# UNITED STATES PATENT AND TRADEMARK OFFICE

APPLICATION NO.	FILING DATE	FIRST NAMED INVENTOR	ATTORNEY DOCKET NO.	CONFIRMATION NO.
10/786,493	02/24/2004	Isao Hayashi	1232-5306	3134
27123 7590 03/12/2007 MORGAN & FINNEGAN, L.L.P. 3 WORLD FINANCIAL CENTER NEW YORK, NY 10281-2101			EXAMINER TSO, EDWARD H	
			ART UNIT	PAPER NUMBER
			2838	
SHORTENED STATUTORY PERIOD OF RESPONSE		MAIL DATE	DELIVERY MODE	
3 MONTHS		03/12/2007	PAPER

### DETAILED ACTION

This Office action is in response to the amendment filed 12/15/06. Claims 3-5, 7-15 are pending, of which claims 14 and 15 are new, while claims 3-5, 7-13 are withdrawn.

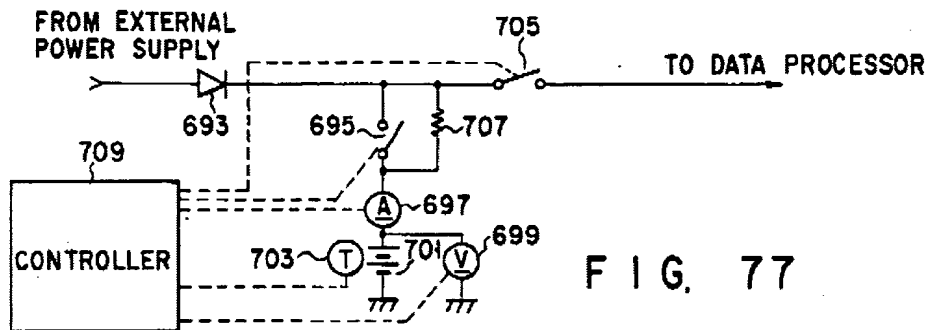
Darmawaskita discloses a battery charger 100 for charging a battery, comprising:

a power input unit, adapted to input direct current power [see column 4, line 57];

a detector 116, adapted to detect a DC voltage input;

a converter 110, adapted to convert the input direct current power to output converted direct current power having a voltage different from a voltage of the input direct current power [see column 4, lines 49-62];

embodiment of the invention is illustrated. The integrated circuit package charger logic and control is generally represented by the numeral 100 and comprises a microcontroller 102, a switch mode power supply (SMPS) controller 104, an analog-to-digital converter (ADC) 106, and an analog input multiplexer 108. A power converter 110 converts a power source (not illustrated) such as AC mains or a larger battery system such as found in an automobile to a **voltage** and current appropriate for charging a battery 112. The SMPS controller 104 of the charger logic and control 100 controls the power converter 110 and monitors battery 112 current and/or **voltage** during charging thereof.

and a controller 102, adapted to control a switch SMPS, so that the power converter converts a power source input to a voltage and current appropriate for charging the battery [see column 5, lines 52-64].

Darmawaskita does not disclose quick/rapid or trickle charging.
